CITY OF PORTLAND, MAINE

April 18, 2018

Project Name: Westerlea View Lofts (Amendment to 2016/2017 Approval)
Project ID: #2018-046
Address: 75 Chestnut Street, Portland
CBL: 026 E010
Applicant: A & M Partners, Inc Lou Woods
Planner: Jean Fraser

Westerlea View Lofts: Amendment to previous approval for 54 unit residential development and commercial space

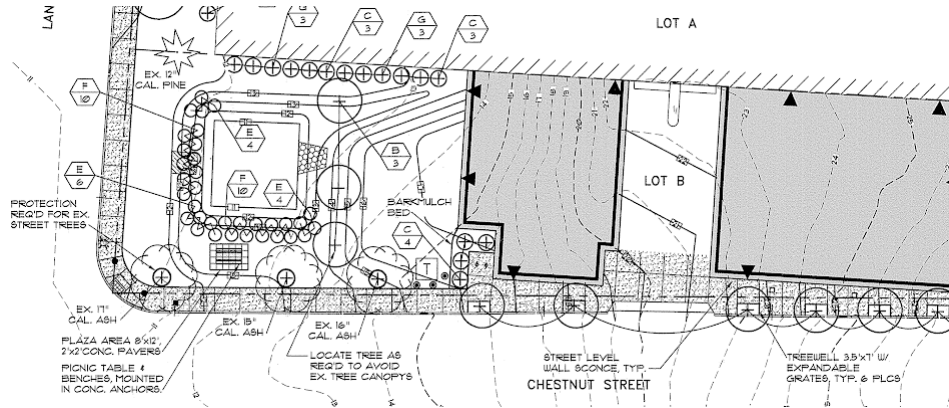
We would like to see city sidewalks where possible accommodate our standard sidewalk plow which is 51" wide and 150" long. Currently this section of sidewalk is not cleared by the city but we like to build all future sidewalks to the standard in case someday we need to.

The proposed building angle with columns appears that it could be challenging for snow clearing and pedestrian travel. We note in the downtown that while tree grates are accessible ped traffic seems to avoid walking on them. Truly - the columns appear to pose the biggest challenge to an open, navigable with the closeness of the street trees.

- a) Adjust the spacing of the trees on the uphill side of Chestnut. Shown as H 6, by moving the second tree down from Oxford Street slightly uphill away from the nearby column. The concrete scoring joint marks could be adjusted to fit the new alignment.
- b) Remove (1) tree closest to the column and replant a new tree near the corner of Lancaster Street below the stormwater feature, on the lawn area. This would be between the F-10 & E-6 plant tags on the landscape plan, see below.

My preference would be the later as that space would provide a larger root zone to help the tree establish. From experience the street trees in the sidewalk cutouts have limitations due to lack for root space, (I am thinking the long term view from the tree perspective)

Subdivision Plat

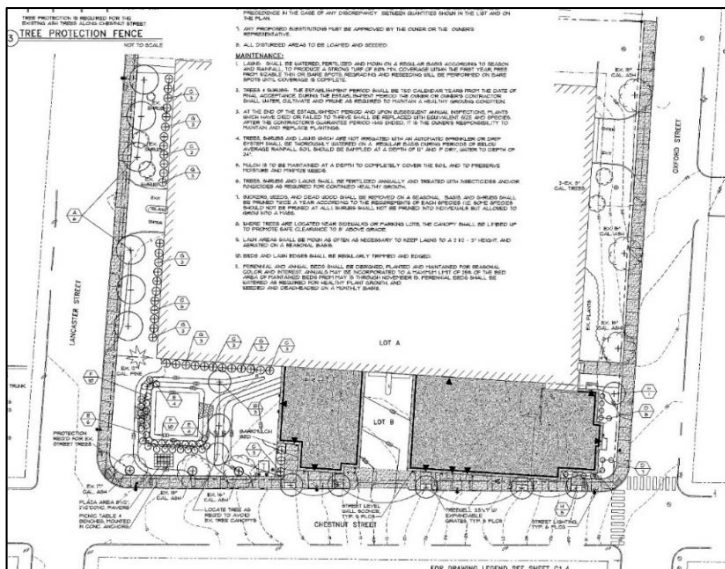
The applicant submitted a draft 2-sheet subdivision plat (*Plan P18*) and staff provided comments in March, 2018 (*Attachment 5*). A suggested condition of approval requires that the plat be finalized to address the staff comments and to reflect all of the easements, parking arrangements and other relevant conditions of any approval.

As Amended (2018):

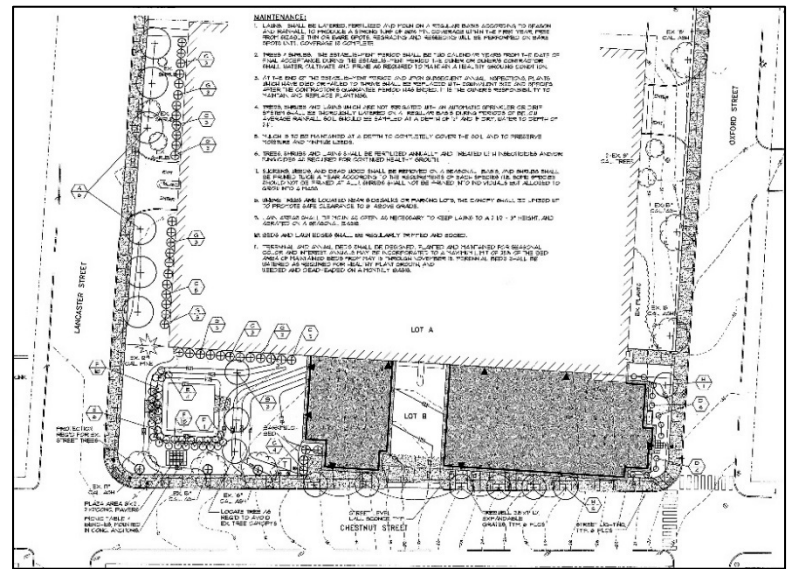
Further review of the amendments in respect of the Site Plan standards has been undertaken regarding the following where the amendments result in revisions. It should be noted that the civil plans (see *Plans P9 and P10*) were originally approved in 2016 before the final design was approved which included columns on the Chestnut Street frontage. The amendments are generally minor, with the main impacts being on the ROW:

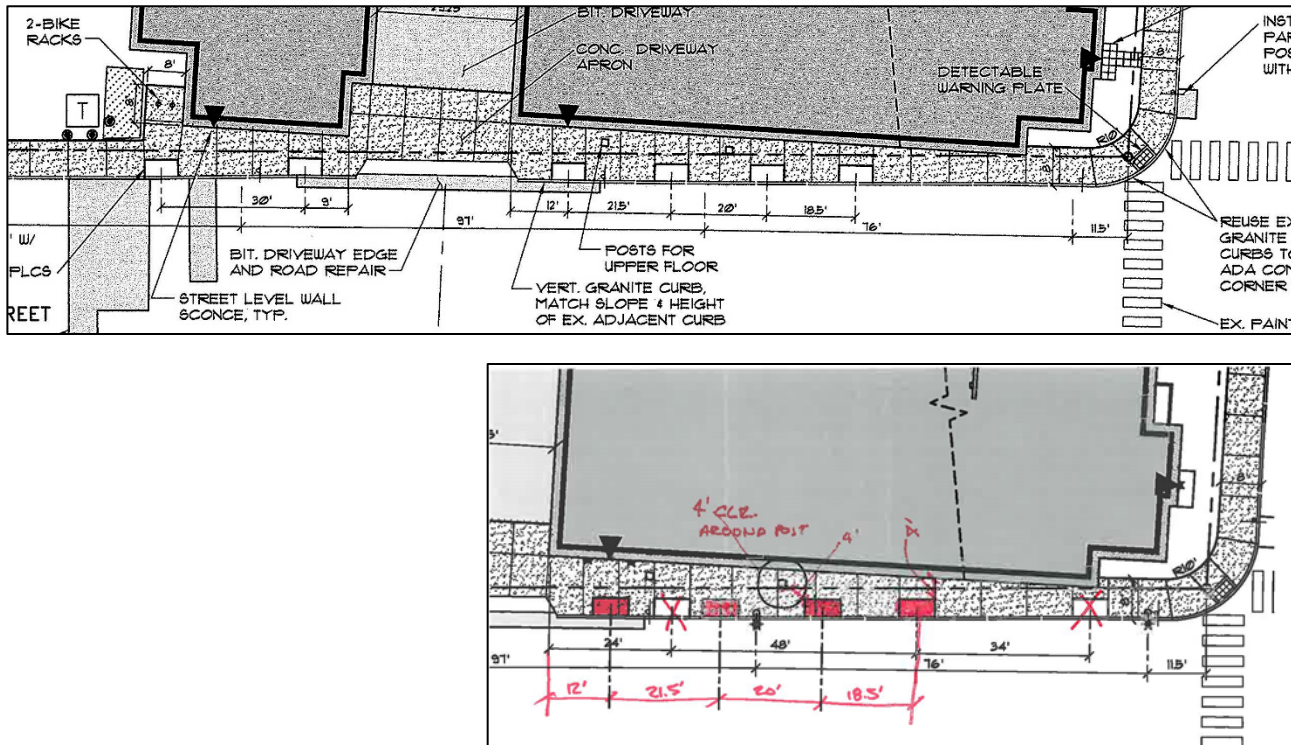
The 8 feet sidewalk incorporated in the original approved plans was a commitment from the applicant during the review and was welcomed as it is expected that this stretch of sidewalk will become a well-used pedestrian link between

Bayside and Congress Street as Bayside is further developed. The approved site plan did not include any columns to support the building within the 8 foot width, but the amended plan has two columns, the nearest being 5-6 feet from the curb.

The combination of the columns and the revised layout of the street trees creates a situation where the path of walking must keep changing direction to avoid the trees and the columns, as illustrated in these “amendment” plans submitted by the applicant (*Plan P19 & Attachment D*):

“...Site Plan sheet C1.2 should be revised to show a direct, intuitive and non-meandering clear width of no less than 5 ‘ of width of sidewalk without having to avoid obstacles”

- ii. That the ROW plans along the Chestnut Street frontage be revised, for review and approval prior to the issuance of a building permit, to:
 - a. Provide a relatively straight 5 foot wide ADA clear sidewalk with no impediments (excepting tree grates in limited locations) within an overall width of a minimum of 8 feet sidewalk;
